Technical Bulletin

37 12 02 January 12, 2012 **2027120**

Transmission Noise When Driving, Possibly from the Differential Area

Figure 1

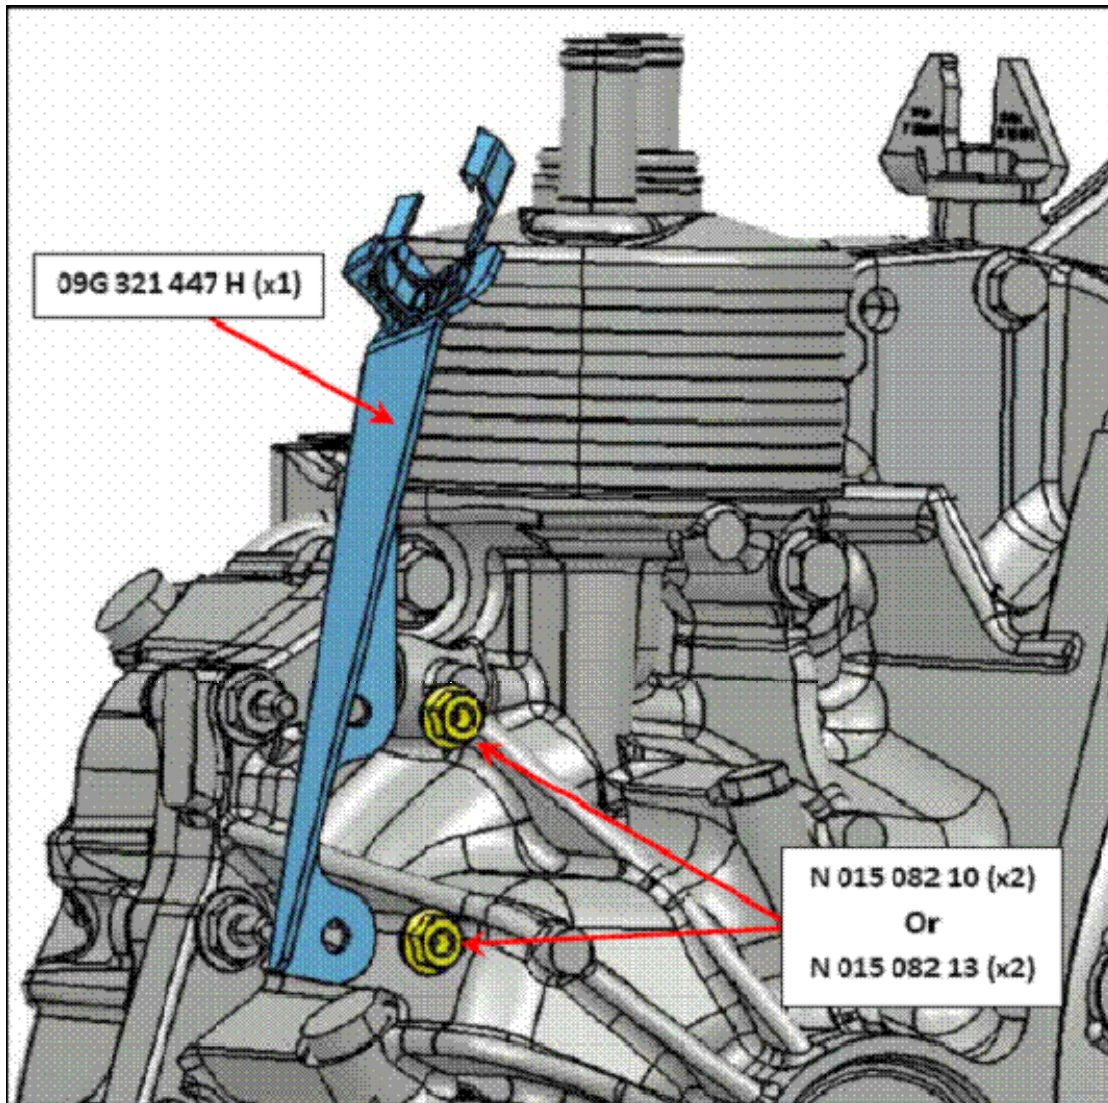
- Disconnect shifter cable from multifunction range switch and from front and rear shifter cable brackets.
- Replace rear shifter cable bracket Part No. 09G 321 447 H (1) and nuts Part No. N 015 082 10 (2) **Or** Part No. N 015 082 13 (2) as seen in Figure 1.

Figure 2

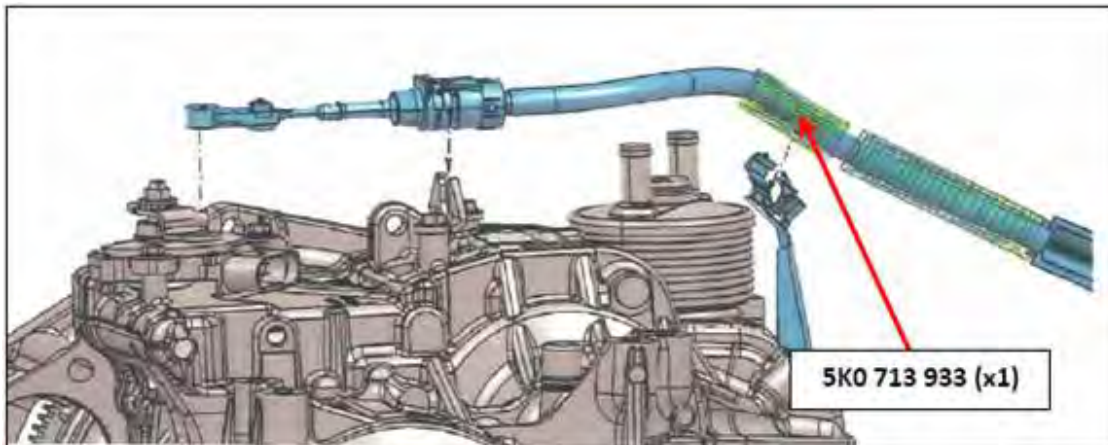
- Install and properly position rubber star hose Part No. 5K0 713 933 (1) onto shifter cable as indicated in figure 2.

Figure 3

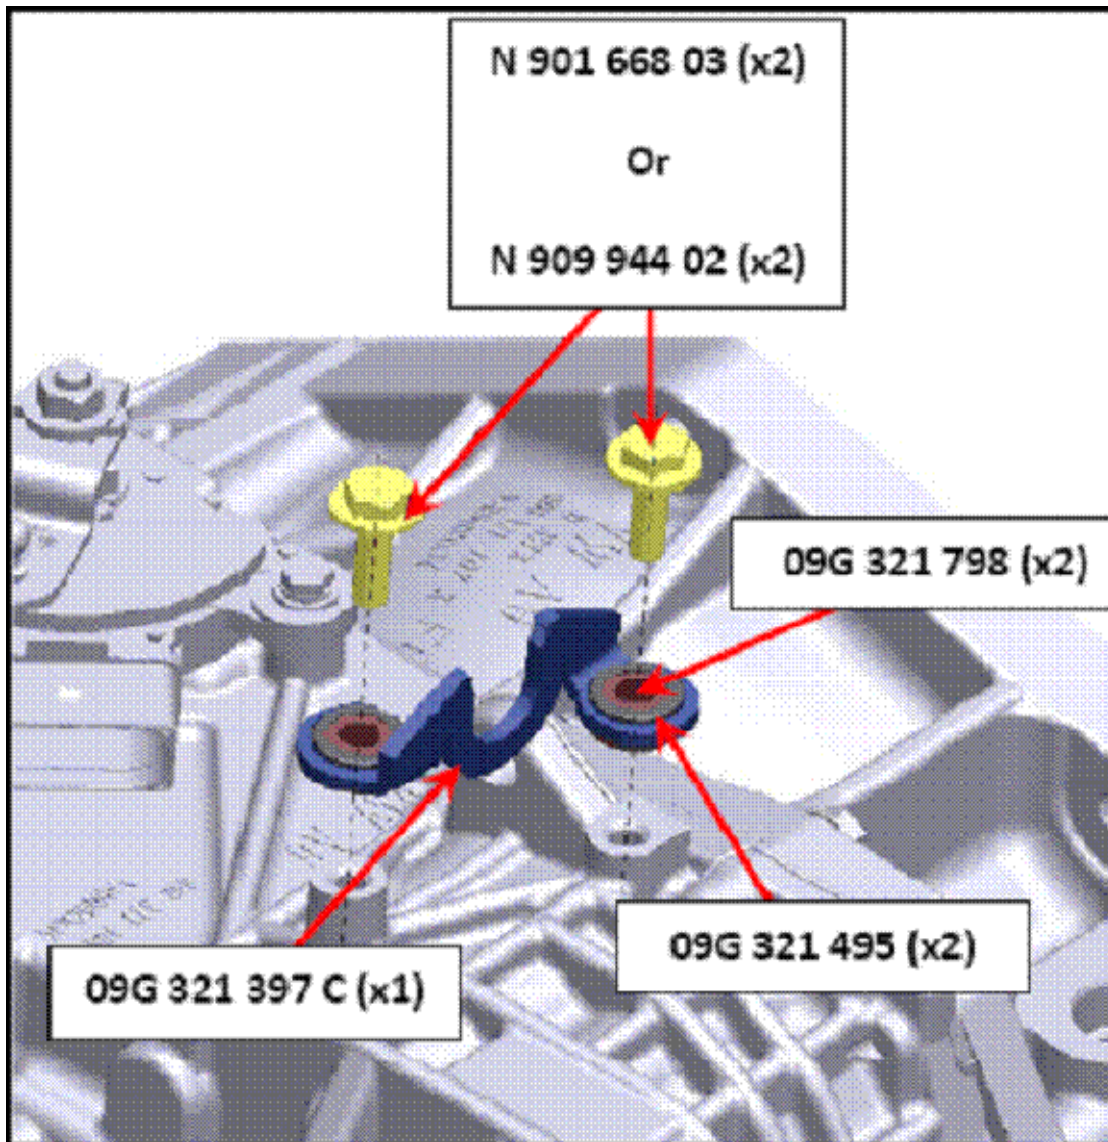
- Install front shifter cable bracket Part No. 09G 321 397 C (1), grommets 09G 321 798 (2), sleeves 09G 321 495 (2) and bolts Part No. N 901 668 03 (2) **Or** Part No. N 909 944 02 as indicated in figure 3.

Figure 4

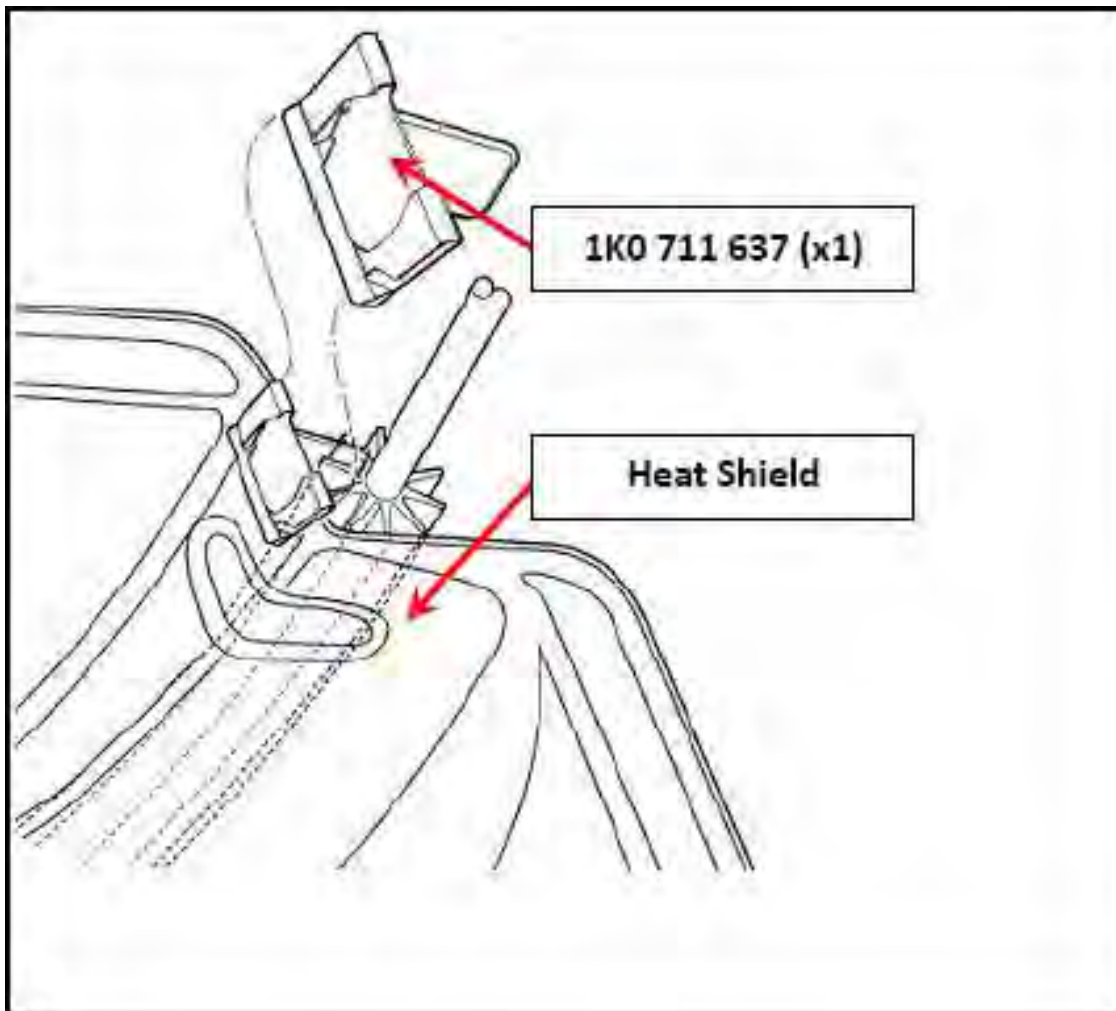
- Install shifter cable retaining clip Part No. 1K0 711 637 (1) onto existing heat shield (Figure 4,5 and 6).

Care must be taken not to distort or damage heat shield. Shifter cable retaining clip used to secure shifter cable to heat shield and restrict shifter cable movement.

Figure 7

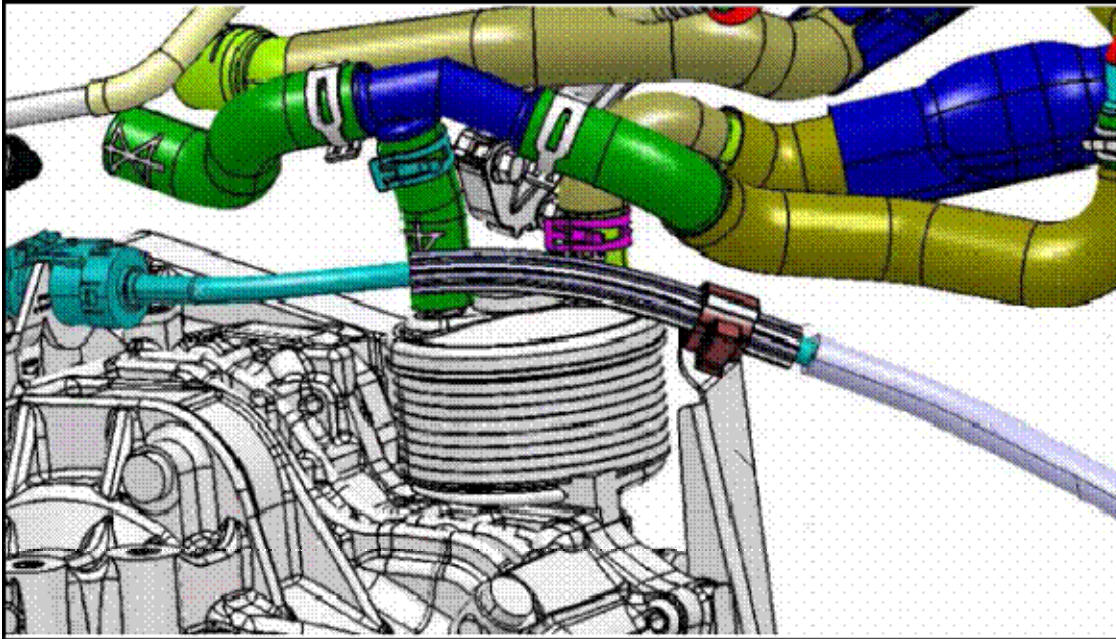
- Reattach shifter cable to multifunction range switch, front bracket and rear bracket, making sure star hose is securely fitted and clamped into rear bracket (Figure 7).
